# SERVICE BULLETIN

PURPOSE : INFORMATION	ISSUE NO. : MSB-07E54-007	DATE : 2007-12-05
SUBJECT : JOINT CONNECTOR (1)		<MODEL> (EUR) 08.1- OUTLANDER (GS45X)(CW0W)
GROUP : CHASSIS ELECTRICAL

## 1. Description:

Since the joint connector (1) has been added to the microphone unit in the hands free cellular phone system circuit for the right-hand drive vehicles, the related descriptions are added and modified in the applicable Workshop Manuals. This Service Bulletin contains the changed descriptions.

Hands Free Cellular Phone System Circuit <LHD>

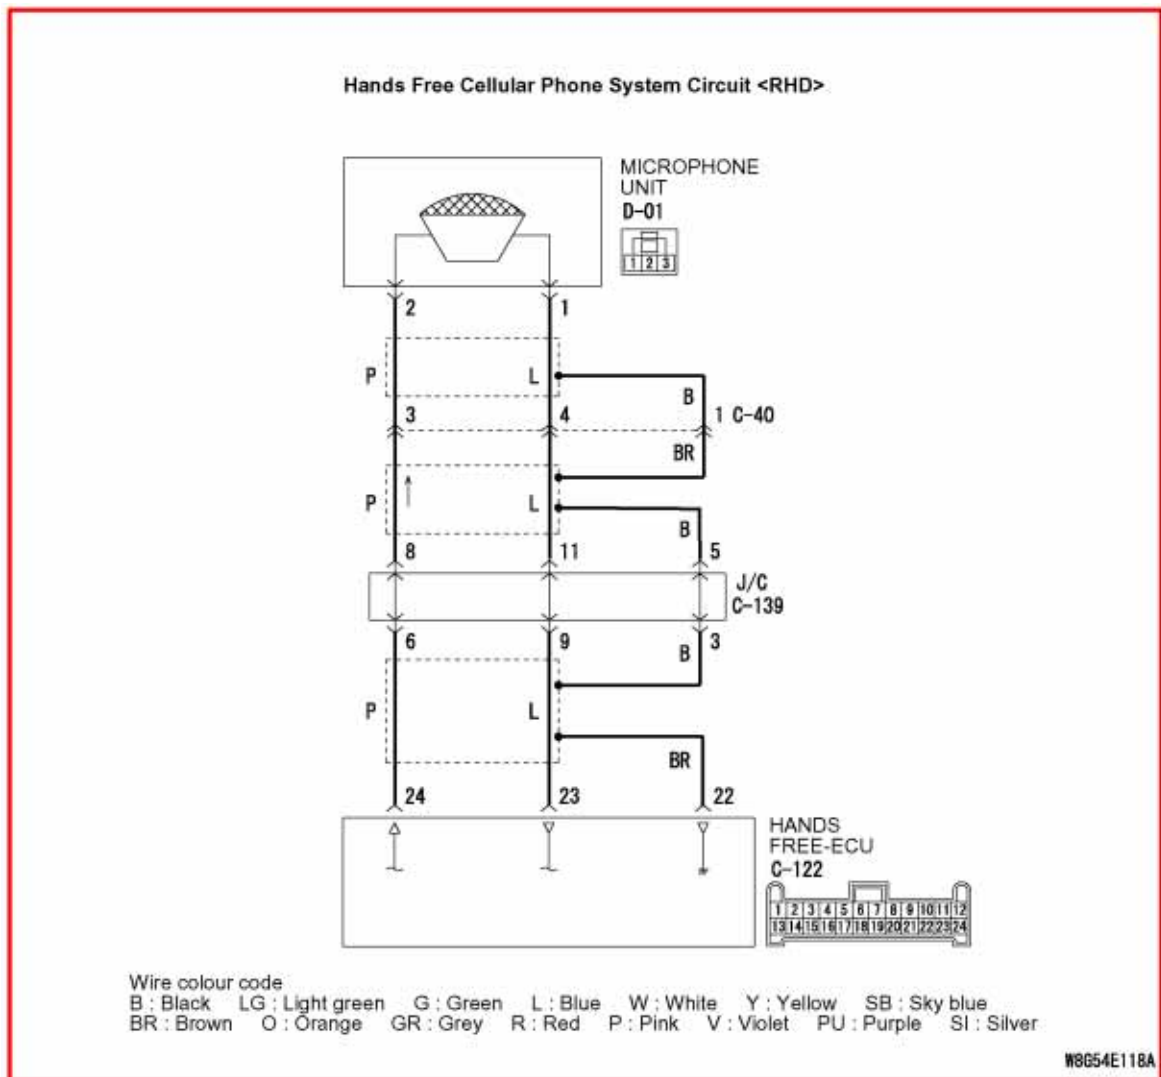
<Added>

Connector: D-01

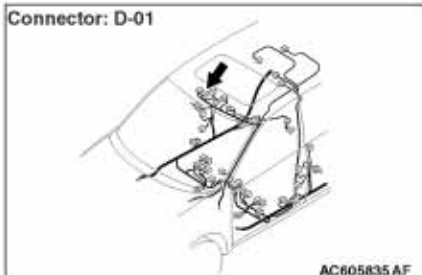
&lt;Added&gt;

Connector: C-139 &lt;RHD&gt;

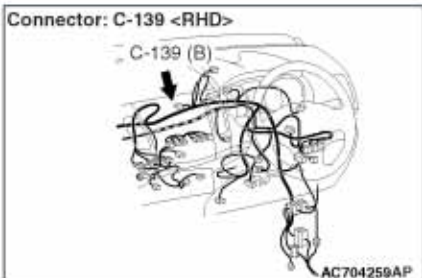
&lt;Added&gt;

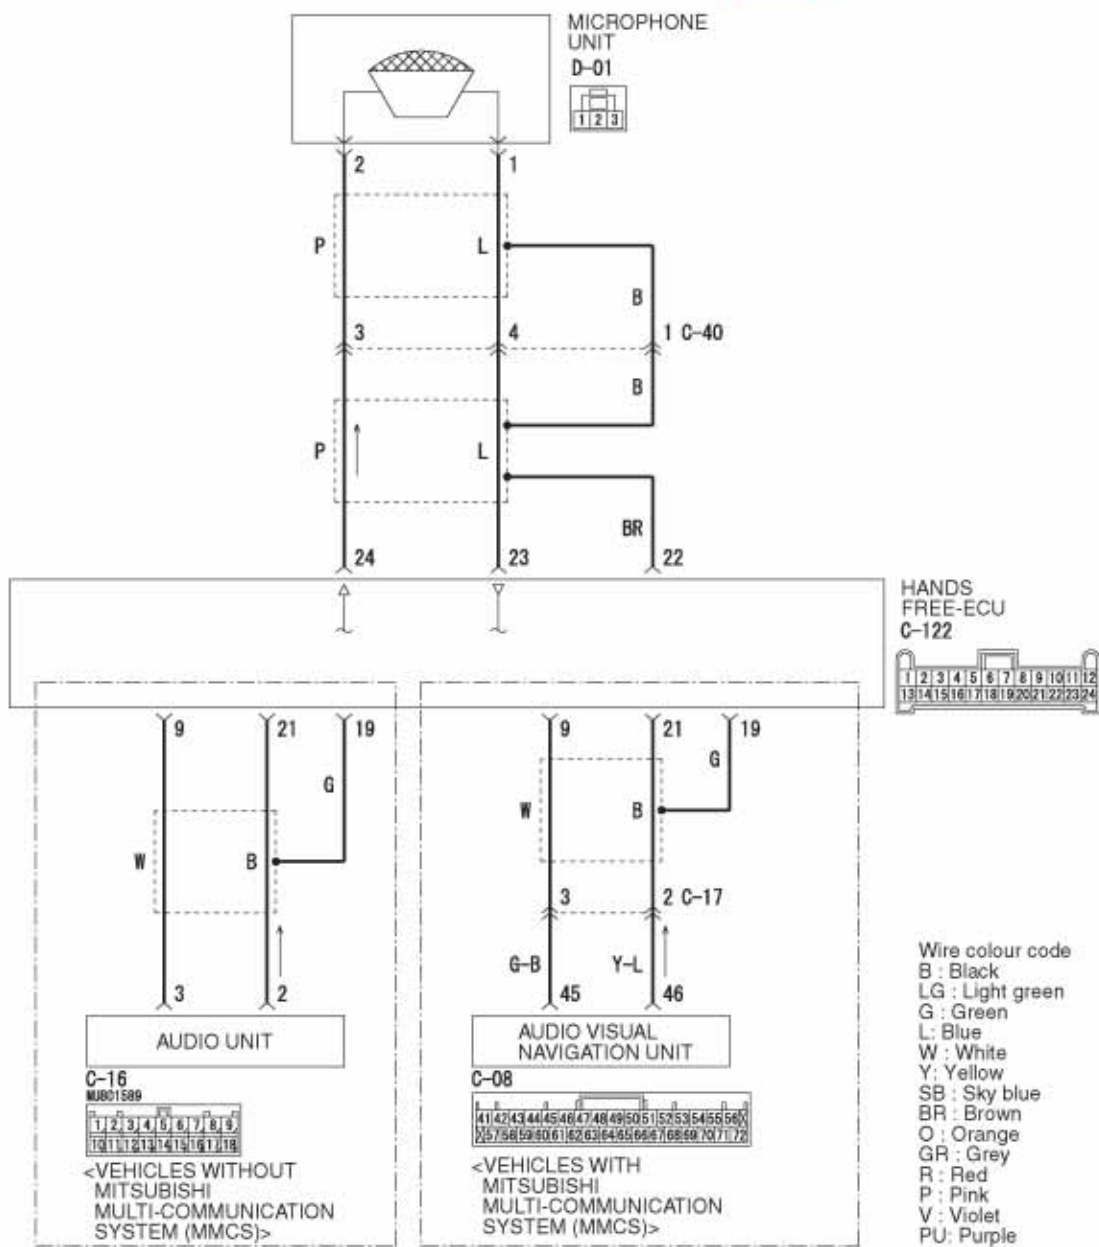
~~NOTE: Prior to the wiring harness inspection, check intermediate connector C-40, and repair if necessary.~~

&lt;Old&gt;

&lt;New&gt;

**NOTE:** Prior to the wiring harness inspection, check C-40 intermediate connector and C-139 joint connector <RHD>, and repair if necessary.

## Hands Free Cellular Phone System Circuit &lt;LHD&gt; &lt;Added&gt;

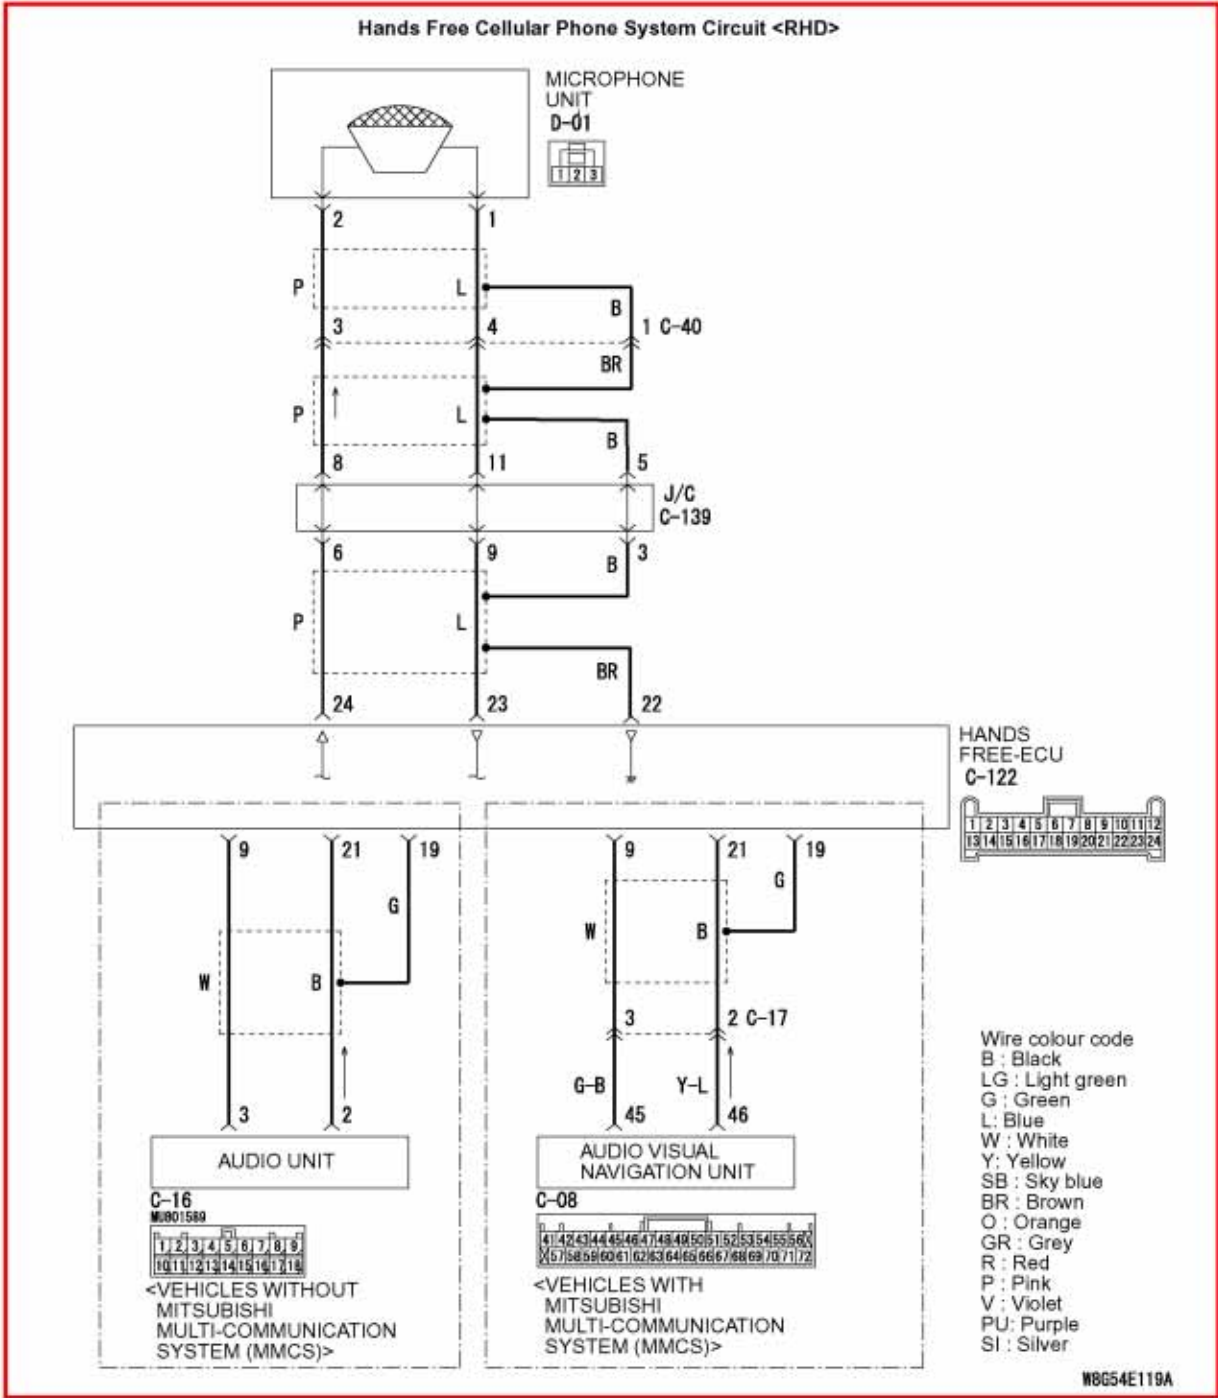
**<Added>**

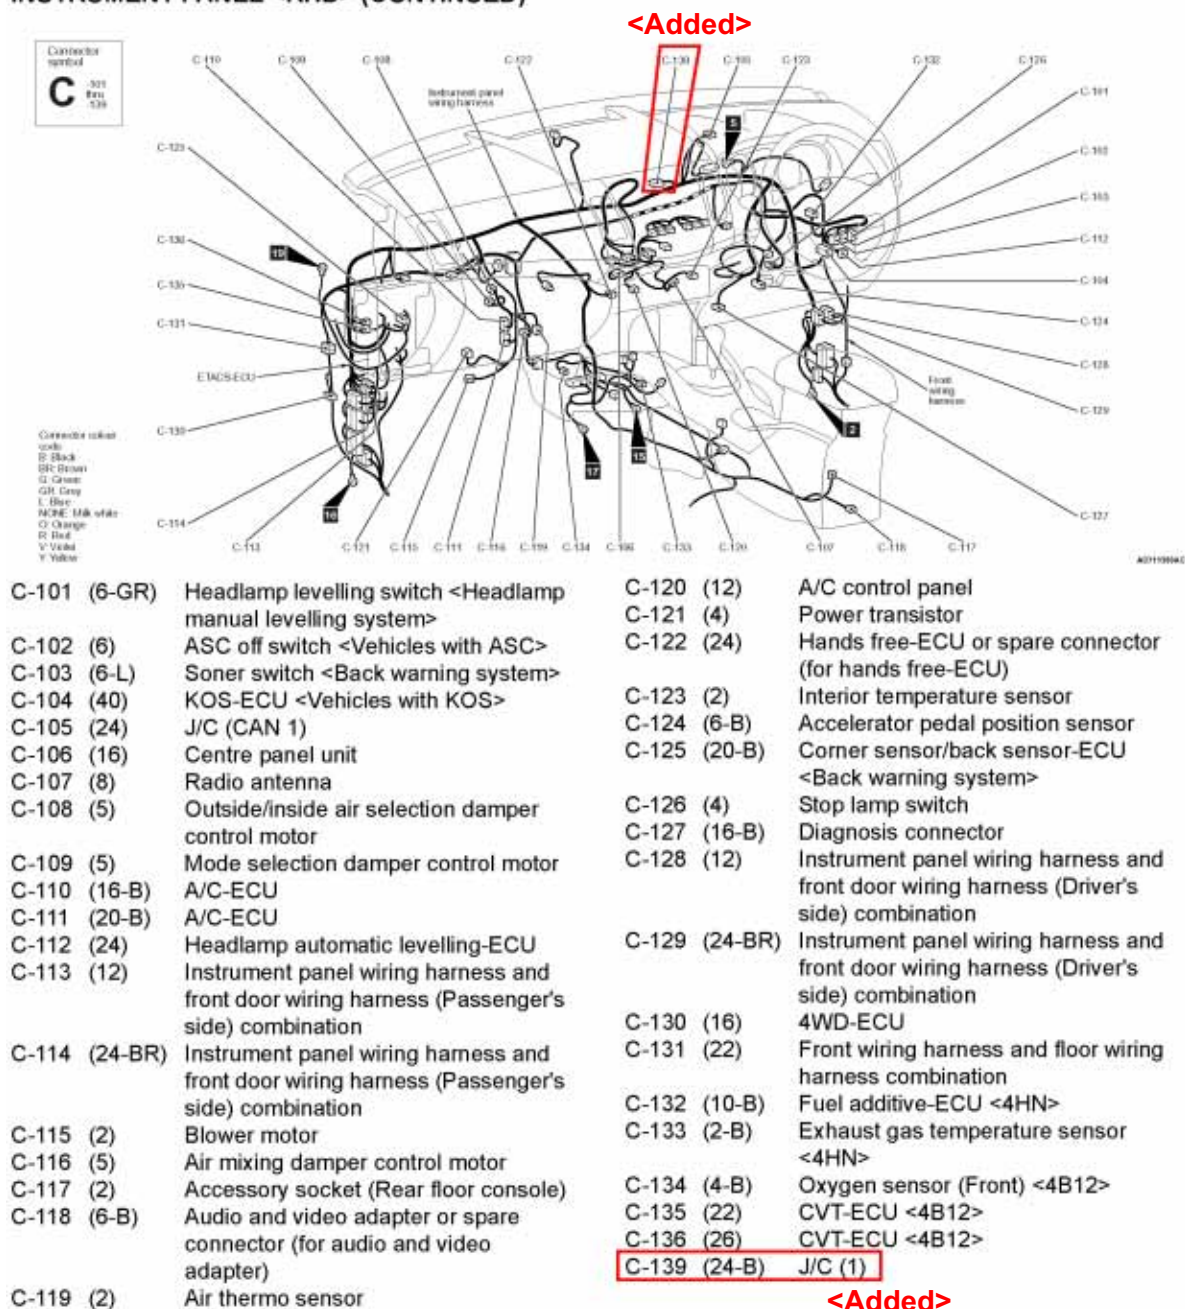
**<Old>**

~~NOTE: Prior to the wiring harness inspection, check C-40 intermediate connector, and repair if necessary.~~

**Q: Is the check result normal?****YES :** Go to Step 11.**NO :** Repair the wiring harness.**<New>**

NOTE: Prior to the wiring harness inspection, check C-40 intermediate connector and C-139 joint connector <RHD>, and repair if necessary.

## HANDS FREE SYSTEM

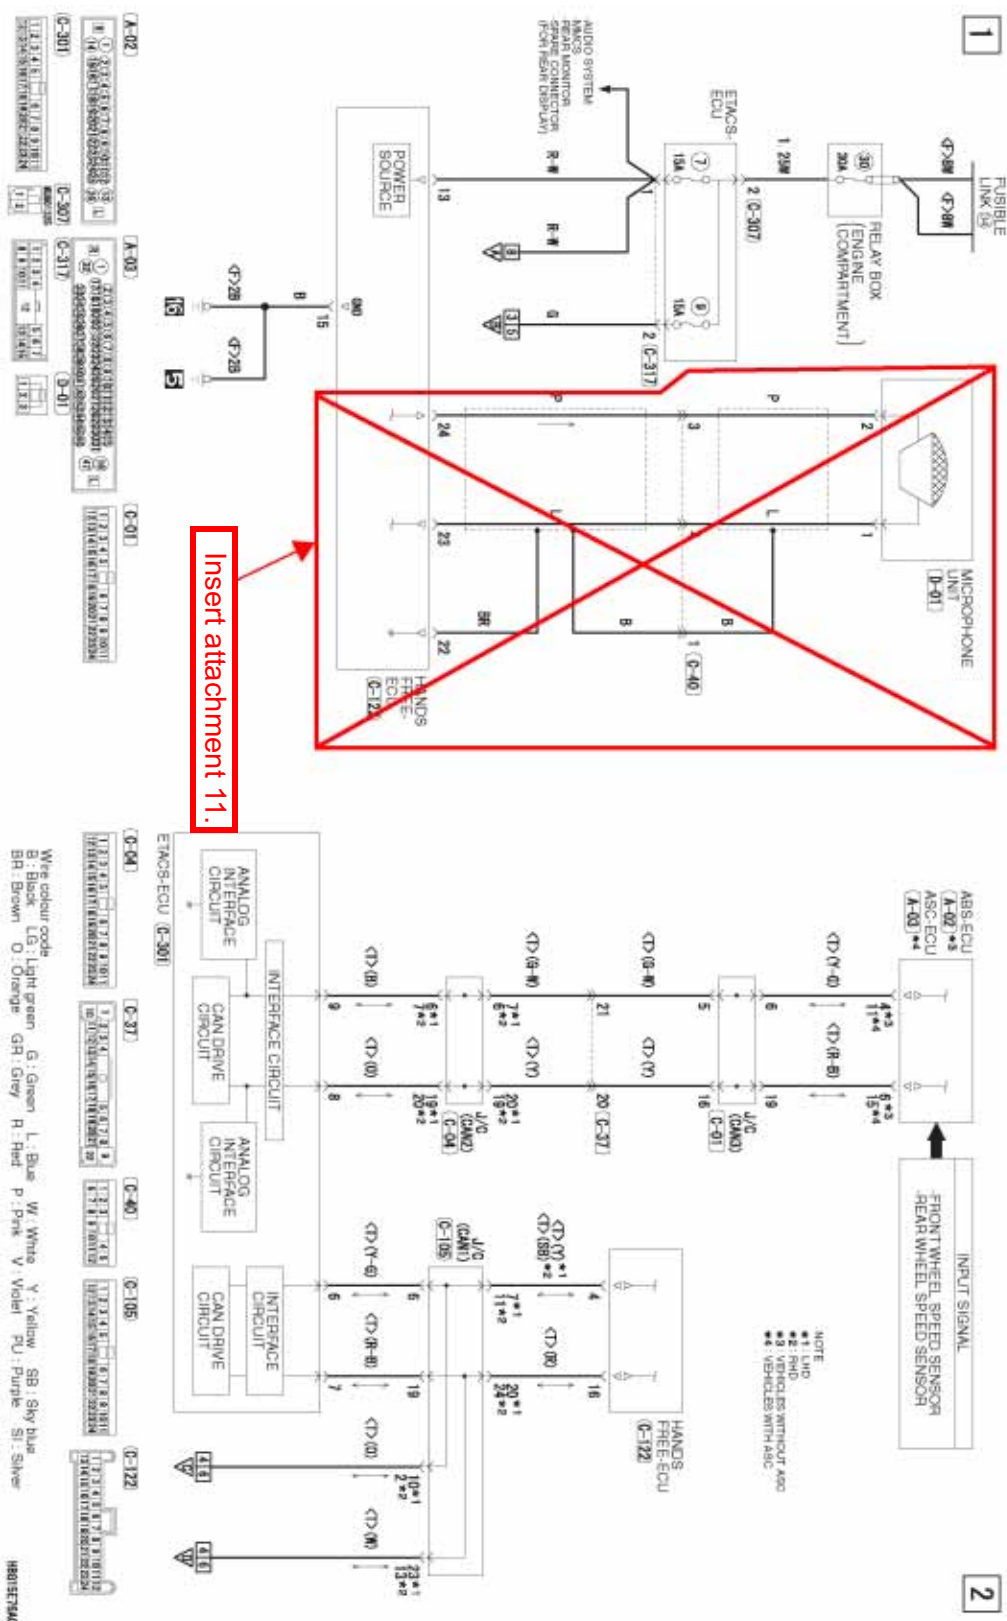
<New>
